August 17, 2022

RE: Expiry - Deficiency Notice  
Application for a Standard Opencut Mining Permit Application  
Marvin Rehbein Site, Opencut #3415  
Lake County  
Executive Consent Order, Docket No. OC-21-11 (FID 2757)

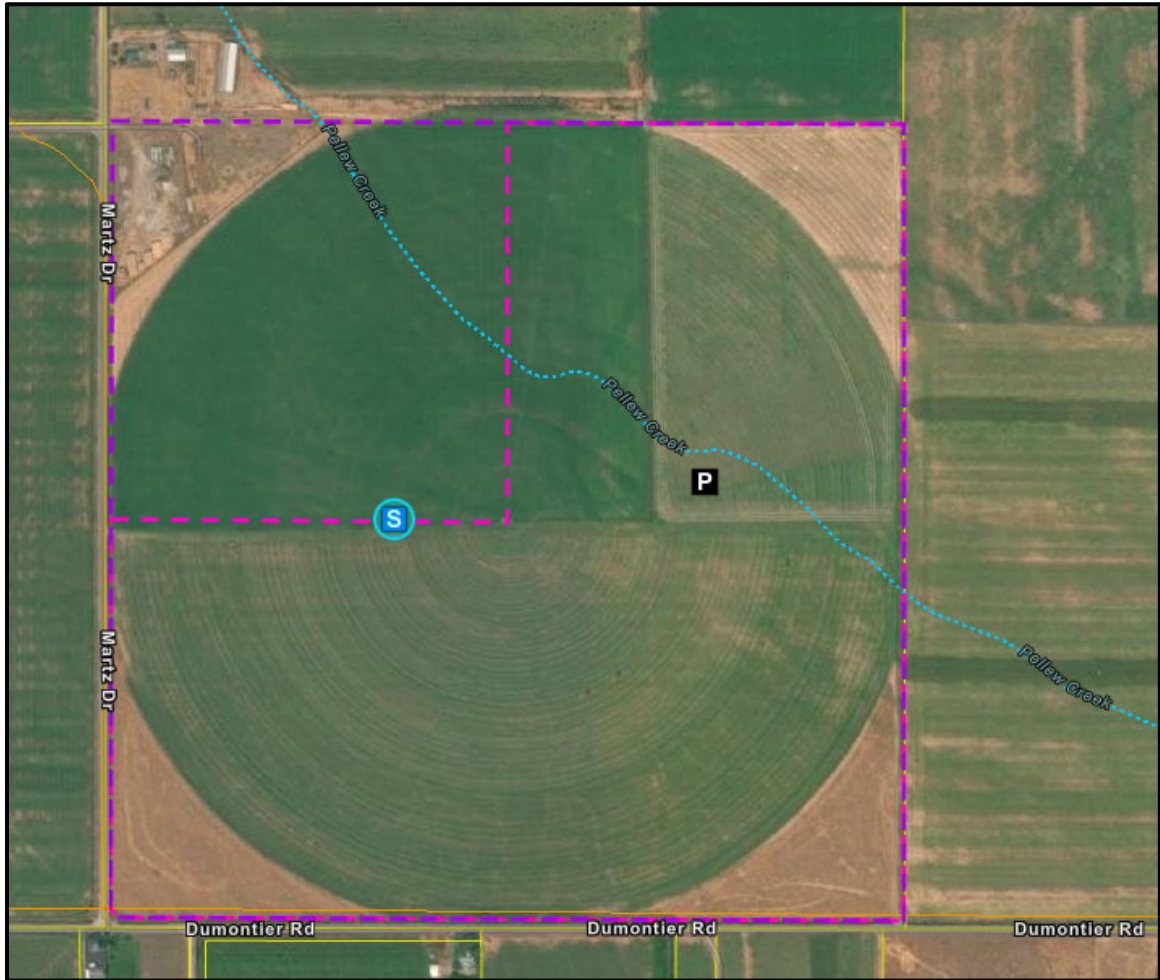
1. **A1-6:** The County was left blank.
2. **B4-1:** In addition to farming, check the 'Fences' box to account for the fences that occur within the permit boundary ARM 17.24.218(1).
3. **B5-1:** Check the 'Stream/Creek' box to account for Pellew Creek that appears to bisect the permit area, (see below picture). Any water features and associated setbacks must be shown on the site map [ARM 17.24.218(1) & 17.24.221].

7. **C1:** Information provided by public comment, and on the USGS map, indicates that Pellew Creek (a stream draining northwestward from the mountains to the east that empties onto alluvial deposits before reaching the Jocko River as a direct surface water tributary) potentially becomes a subsurface stream that flows through the area of the proposed site. See image below. It is unclear, based on aerial photos and information provided by the operator in the application, whether this stream surfaces on the proposed site or is entirely subsurface.

Information provided as part of public comments received by DEQ Opencut indicates that seasonal high groundwater levels in the area of the proposed site may be higher than 30 feet below ground surface (bgs) in some areas of the site. The information provided to confirm water levels is not adequate.
